GOLD PARK HOMES

PROJECT/LOCATION
MCLAUGHLIN AND MAYFIELD
BRAMPTON, ON

SITE PLAN

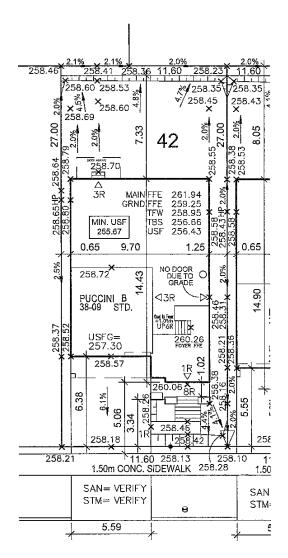
- No final utility location information at this time. Urbantech will not be responsible for future changes to design. Builder should notify purchaser's that street hardware and above ground utility furniture may be added or removed from their frontages.

- Builder to lower underside of footings where adjacent to RLCB leads.
 Exact depth to be determined on site during footing excavation.
- 3) Builder to stake out driveway curb depressions at time of curb installation

- Builder to verify location of all hydrants, street lights, transformers and all other services, if min. dimensions are not maintained as per City standards, builder is to relocate at his own expense.

- Builder to confirm service connection elevations and review for absence of conflict prior to footing excavation.
- 6) Final fence design have not been provided at this time. Purchaser to be advised that actual fencing details may not be as shown on this plan.
